TECHNICAL NOTE

Date:	10/07/2020	Ref:	402.06594.00008 - TN01 v01
Subject:	Middleton Development – Discharge of Surface Water Drainage Conditions Prepared for: Frontier Estates Ltd

1. INTRODUCTION

Figure 1
Groundwater Level at all Boreholes

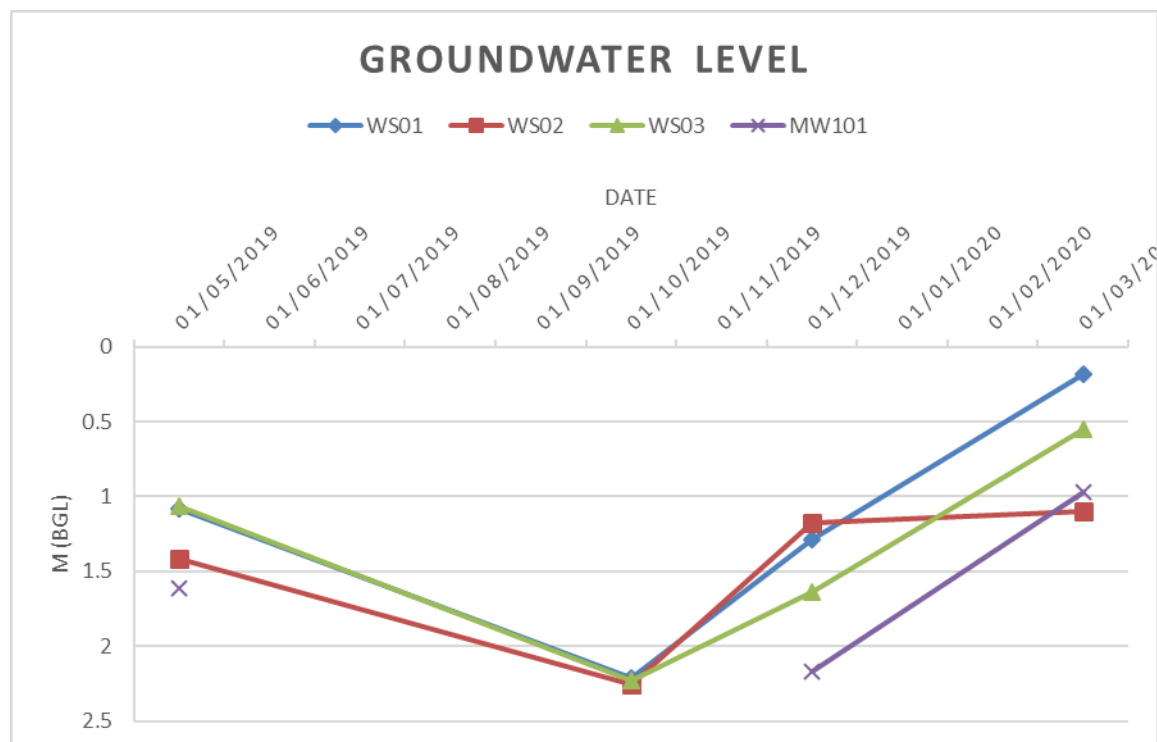
Firstly, we need to be sure that shallow infiltration is not possible, as part of an overall scheme. Please provide a plan showing all the groundwater monitoring point locations and the monitoring results for all, not just WS02. Achieving 1m freeboard between the base of structures and the peak recorded groundwater level is not a requirement in this particular area, so long as the base is above the peak recorded level. This information will dictate as to whether shallow winter infiltration testing will be required.

The results from the manual dip monitoring over the winter period show that the peak water level was 0.18m below ground level at WS01.

In summary, the extensive winter groundwater monitoring has shown that the peak groundwater level in the area of the proposed attenuation storage will be just 0.18m bgl.

Whilst the data logger and the manual dip data correlate well, the final manual reading for WS02 shows a discrepancy. However, the underlying trends are clear that the groundwater level in both the north and the south of the site can be just 200mm below ground level during the early parts of the year.

The SuDS Manual recommends that '*there should be a minimum depth of 1m of unsaturated aquifer material between the base of any infiltration system and the maximum likely groundwater level (taking account of any shifts in groundwater level resulting from extended periods of wet weather)*'. As the peak groundwater level was recorded as 0.18m bgl and in order to protect the Lewes Nodular Chalk formation from pollution it is proposed that infiltration to the ground is discounted.

Figure 4
Route 1 Plan and Section AA'

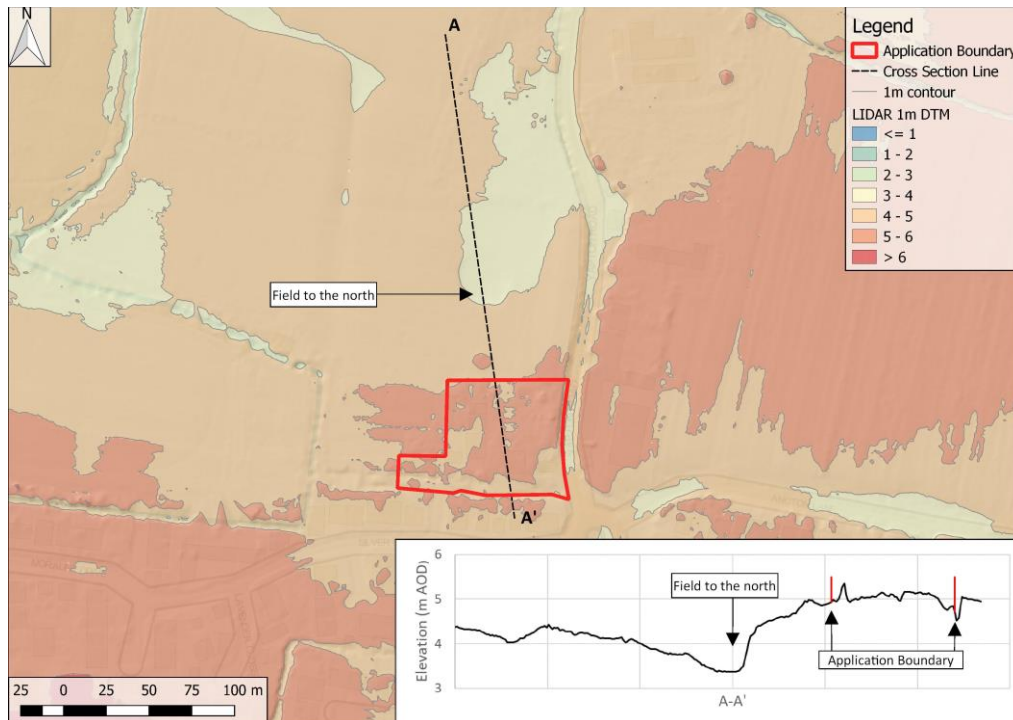
The applicant should also provide topographical evidence to show that no overland/exceedance run off flows from the field to the north will have any detrimental effect on the development/suds."

Ground elevations generally decrease northwards towards the Ryebank Rife, which is located approximately 800m north of the site. As shown in Figure 4, the proposed development is located at a higher elevation (approximately 5m AOD) compared to the field located to the north of the development (approximately 3.4m AOD). Ground elevations immediately north of the field are also situated at a lower elevation than the proposed development, with the highest point situated at approximately 4.4m AOD. Therefore, any surface water ponding in the field will preferentially escape northwards away from the site and back towards the Ryebank Rife.

From the above analysis of the two most likely flow routes it is considered that no surface water runoff from a pond in the field will impact the proposed development.

Site: YAPTON POULTRY FARM
Project: MIDDLETON RESIDENTIAL
Date: 01/07/2020
Drawing: SITE VISIT DISCUSSION
APPENDIX 02

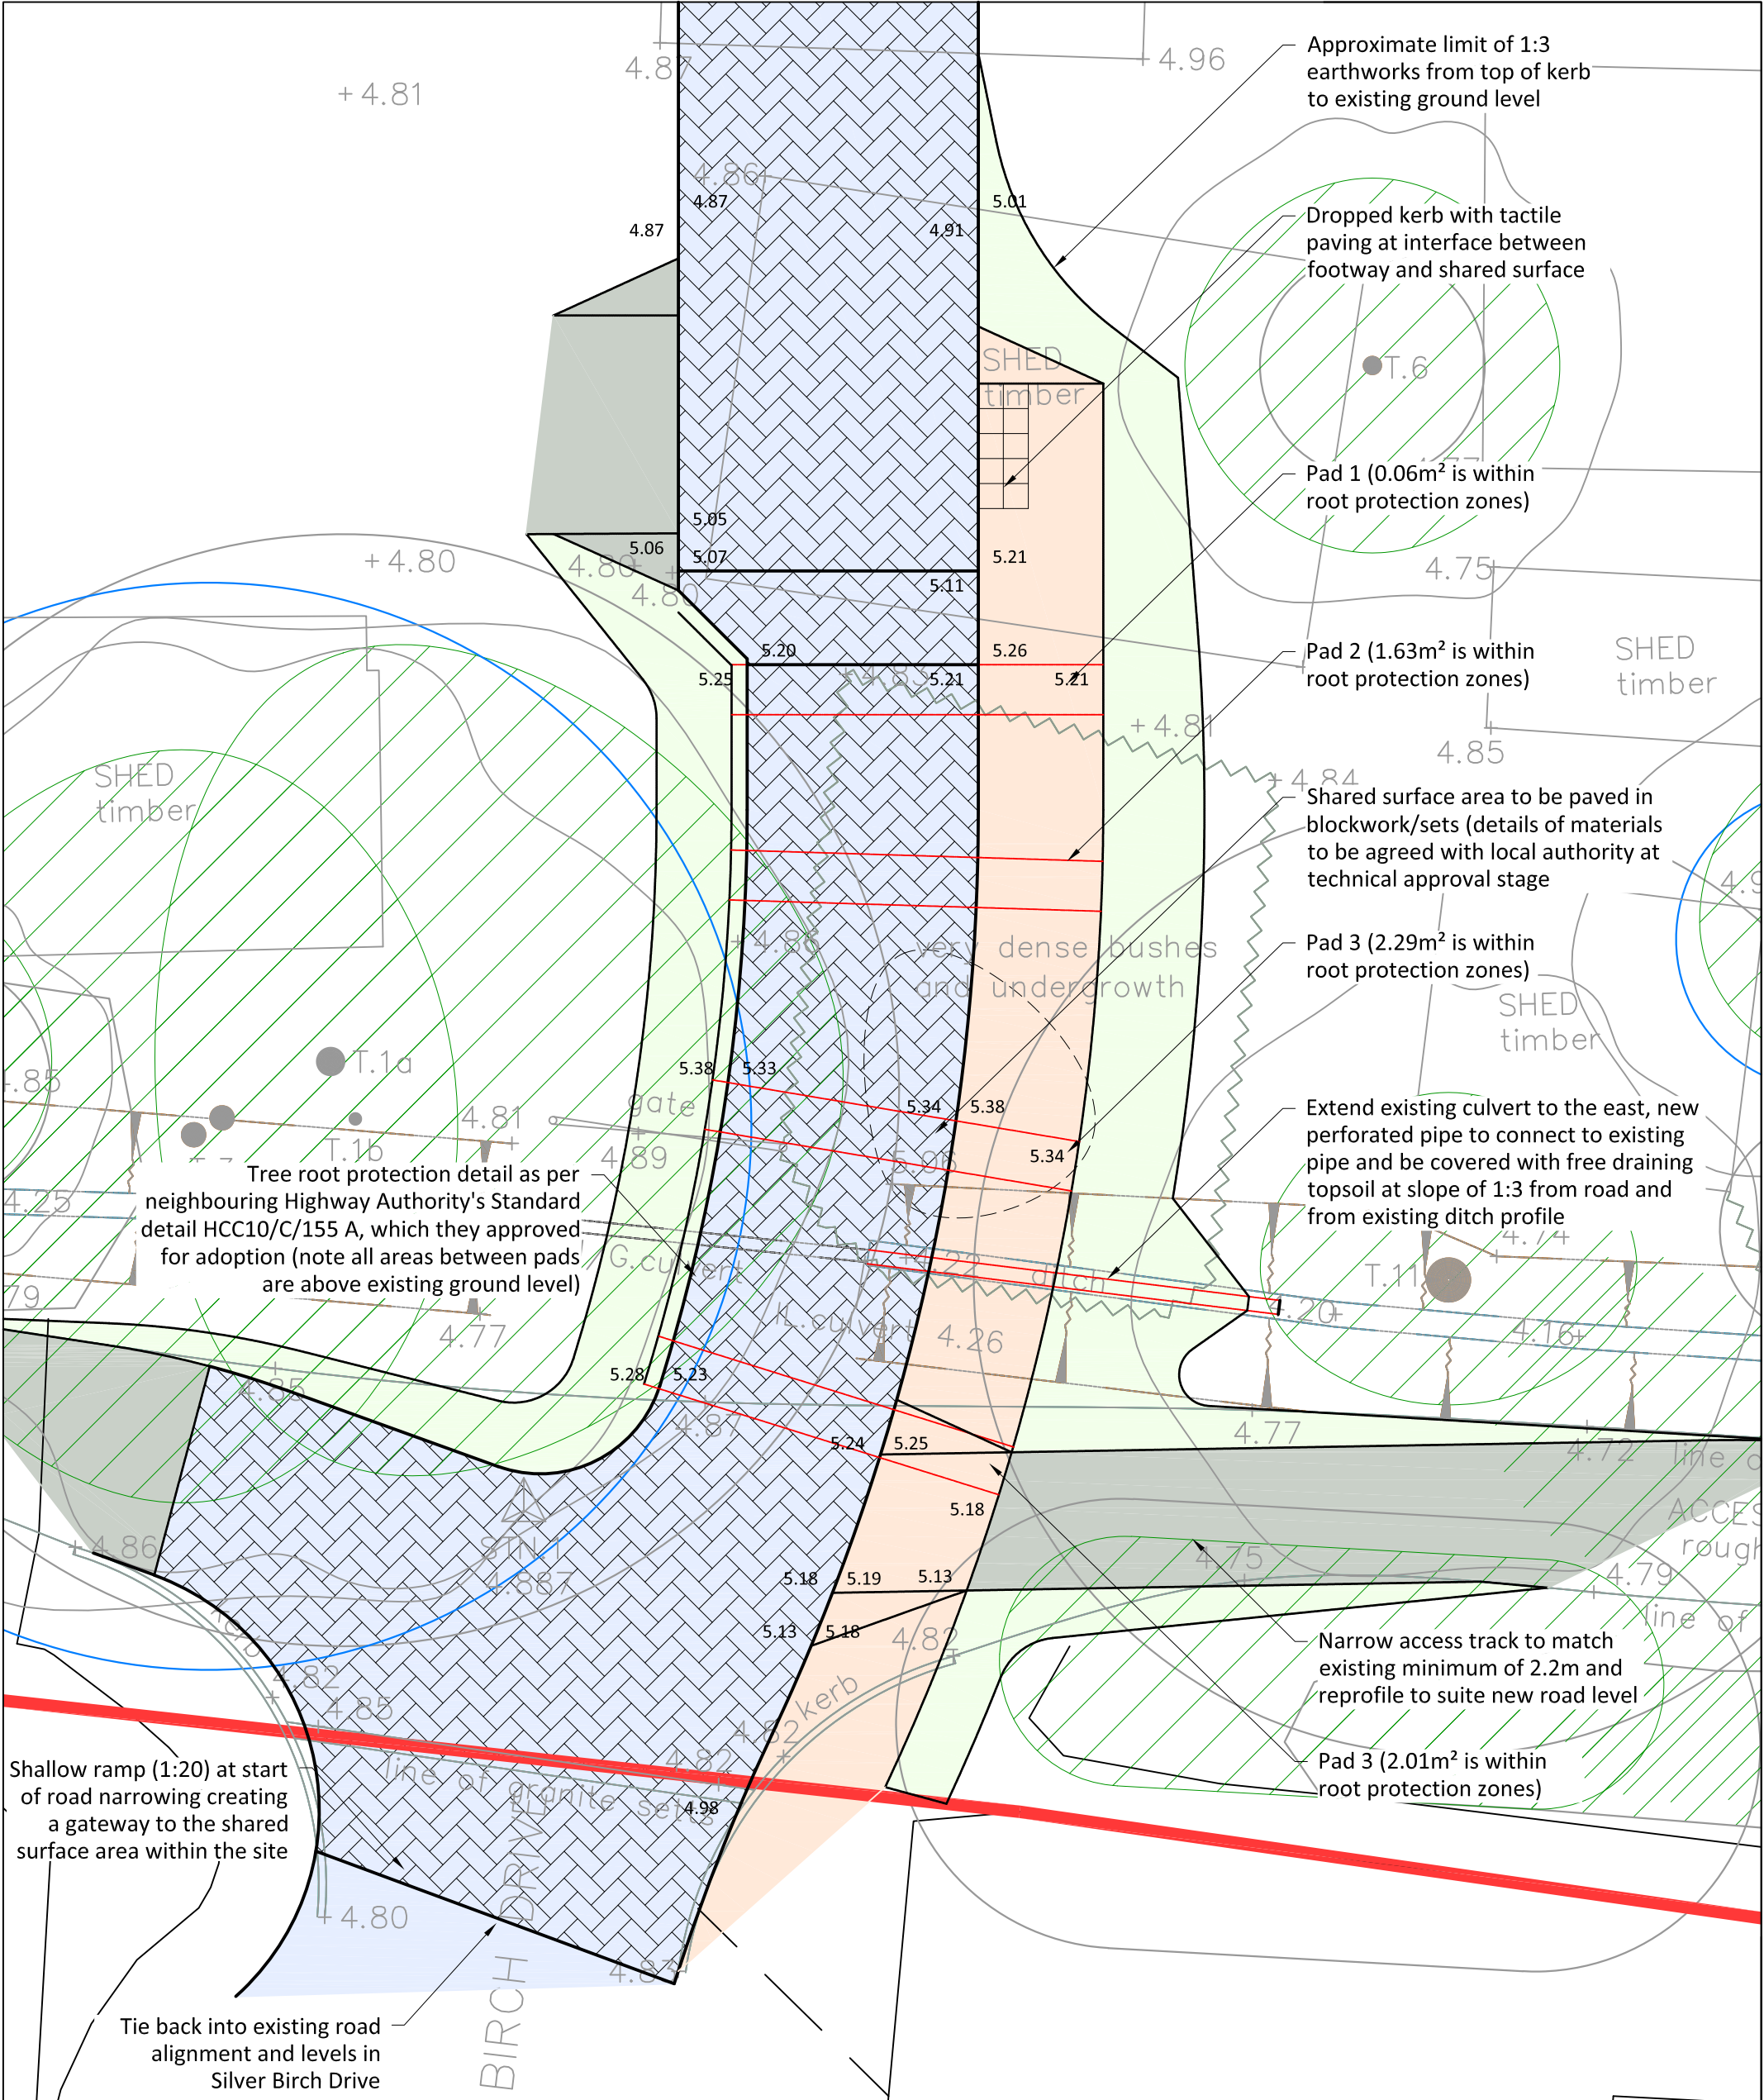
Regarding the ditches on the southern boundary, it is very likely that these will need improvements and I suggest a meeting takes place on site to look at these. Land Drainage Consent will be required for any alterations to them, including culverting and any discharge structures. This will all need to be fully detailed on the drawings.

A site visit/meeting was held on 26/06/2020 between Paul Cann (Arun DC) and Andrew Dannatt (SLR Consulting). Whilst the meeting discussed all the outstanding issues raised by Arun DC, the following scope of work was discussed and agreed to improve and make good the north and south ditches that run either side of the public footpath that runs along the southern site boundary.

- i. Desilting/clearing the ditches to the headwall
- ii. Jetting of the culverts
- iii. Remove existing minor tree from the bed of the ditch
- iv. CCTV check survey to determine if tree has damaged the culvert

- i. Desilting/clearing the ditches to the headwall
- ii. Replacement culvert same diameter (225mm), twin wall poly or concrete
- iii. Pipe bed/surround of concrete or slab over for the access
- iv. Headwalls to be WSCC/Arun DC spec or brick/bagwork
- v. Outfall can be precast, must not encroach into stream, invert just higher than bed. No need for erosion control
